CITY OF CROSSLAKE

PLANNING COMMISSION/BOARD OF ADJUSTMENT

STAFF REPORT

RIVER TRAIL ROAD

Preliminary Plat of
RIVER TRAIL ROAD
Section 28, Township 137 North, Range 27 West
Crow Wing County, Minnesota

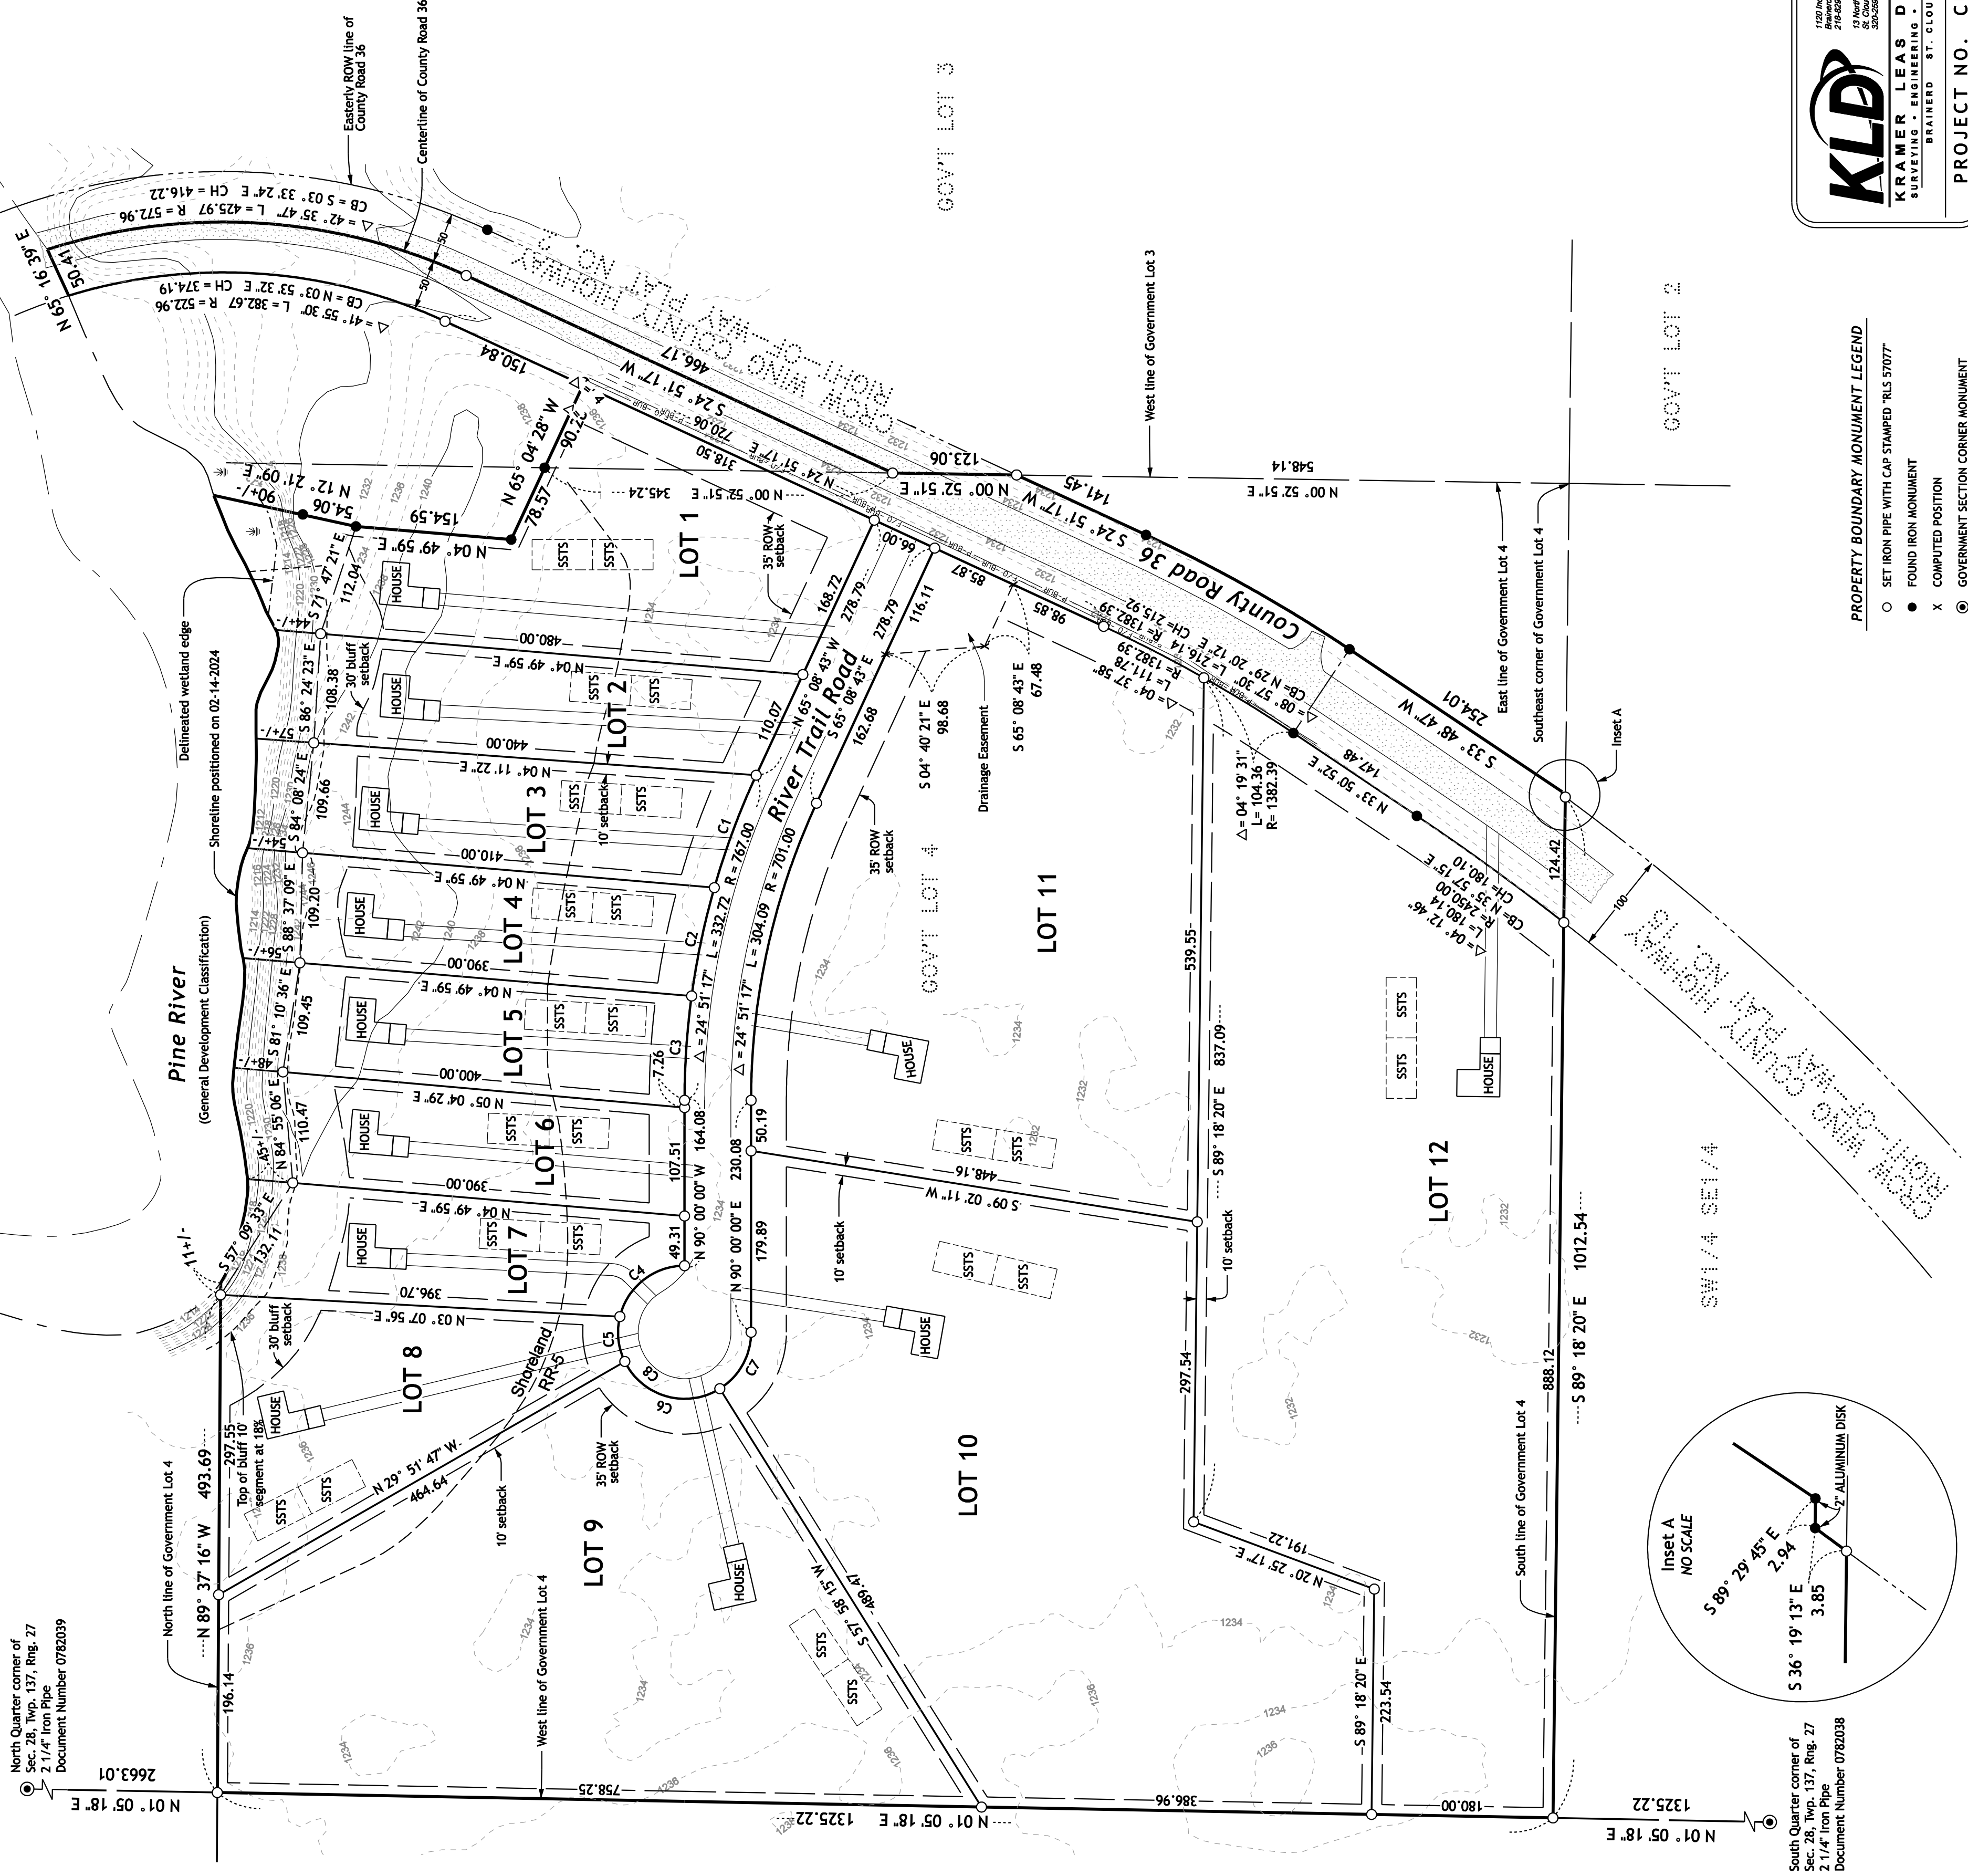
1. The removals plan shows an existing CMP culvert being removed at an existing entrance to CSAH 36, but there is not a new culvert being put back. Is this entrance being permanently removed?

2. The typical section in the Subdivision Road System standards for the Minor Rural Roadway shows a ditch fore slope of 4:1 and backslope of 3:1. Based on scaling of the grading plans, the design appears to be correct. However, the typical section for the roadway in the plans show a 3:1 fore slope. This callout should be changed.

3. The plans show the River Trail Road entrance as a high point with no culvert connecting the county ditch on each side. According to lidar contours on the County GIS, it looks like all water in this ditch flows north to the Pine River. Please review and verify drainage direction relative to the proposed River Trail Road intersection with CSAH 36.

4. The plans indicate the outlet for the basin as the county ditch in the CSAH 36 R/W. Water overflow can erode slopes, especially with sandy soils common in Crosslake. Verify with County their acceptance of proposed design discharge to County ditch.

5. Provide 2 soil borings to depth of 8' to confirm soil characteristics along proposed road centerline, We recommend at Station 3+00 and 8+00. The boring work should classify the soil and provide standard penetration values (N-values).

6. Verify plans list the City of Crosslake or Crow Wing County as responsible agencies.

1. Yes, the existing entrance is proposed to be permanently removed.
2. I interpreted a 3:1 allowable as the maximum slope, but correct the design does have a 4:1 slope. Typical section in the plans has been revised to reflect a 4:1 in-slope and 3:1 backslope

3. Correct, the proposed entrance is at the high point (relatively speaking – ditch is near level going north or south but then slopes down to the river as you get closer and also drops elevation going south by about .5') We can provide our survey data if you would like to review.
4. The model was updated to include the ditching along the roadway along with the addition of a berm within the ditch at the R/W. The 100-HWL for the basin is now 1233.14 which is below the EOF of 1233.5. This prevents to the County R/W and the concern for erosion.
5. We have ITT scheduled to complete the borings this Friday and we will forward the boring logs when available.
6. Noted, see river plan sheets.
7. Noted, see revised HydroCAD Report and Drainage Exhibit.
8. See revised HydroCAD Report and Drainage Exhibit. Basin 1B retains the 100-yr event for the roadway and lots 1-8.

Due to the mature tree coverage on the site and the linear length that would be required to construct a single basin to retain runoff from lots 9-12, we are proposing an individual basin per lot. These basins are included in the HydroCAD report with the following note "FUTURE LANDOWNERS OF LOTS 9-12 ALONG WITH POTENTIAL FUTURE LOT SPLITS (TOTAL OF 8 LOTS) WILL BE RESPONSIBLE FOR CONSTRUCTING THEIR OWN INFILTRATION BASIN. 1,800 CU. FT. BASIN - 2' DEPTH, 15'X30' BOTTOM WITH 5:1 SIDE SLOPES - CONSTRUCTED DOWN GRADIENT OF IMPROVEMENTS."

9. The City would be responsible for maintenance of the South Basin/1B along with the roadway. Maintenance will be minimal with the pretreatment of the ditching. After soil stabilization and established vegetation which is when the City would take it over would only consist of mowing. Mowing
